Title: Hinge Batten Fitting Security

Identification	SB-019
Status	Active
Issue	1
Issue Date	01-09-2015
Applicability	All Airborne Windsports Wings
Compliance	100 Hourly line maintenance
Reference Material	Airborne Engineering Report 15/025/DS

1. Damage to the Latch

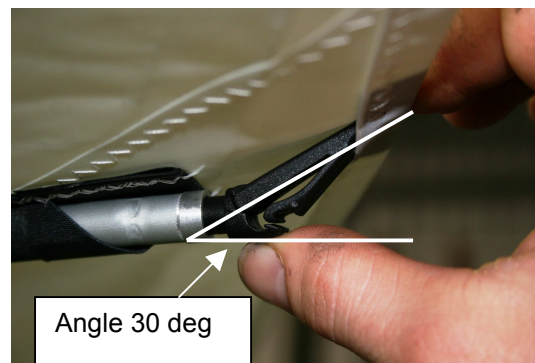
It is important that the locking latch is depressed adequately to clear the capture clasp when unloading.

Testing of fittings that have been unloaded without depressing the locking latch adequately have seen a reduction in latch security.

If the clip is opened by force without properly depressing the latch it can result in a 25% reduction in latch strength. The reduction in strength can be greater and continual improper unloading will see further degradation in strength of the locking mechanism.

Sand and grit on the latch area will also reduce the latch strength. Ensure area is clean.

2. Over Tension

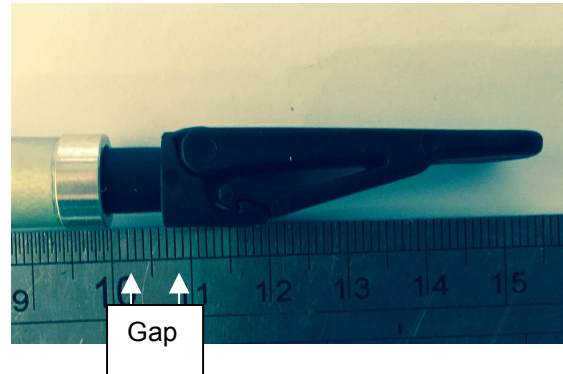
Over tensioning of battens will cause degradation of handling as well as overloading the latch. In particular, a mylar sail tends to shrink as it ages so checking of the batten tension periodically is required.

The correct tension is applied to the batten when loading with minimal pressure applied an angle of 30° is achieved (See diagram).
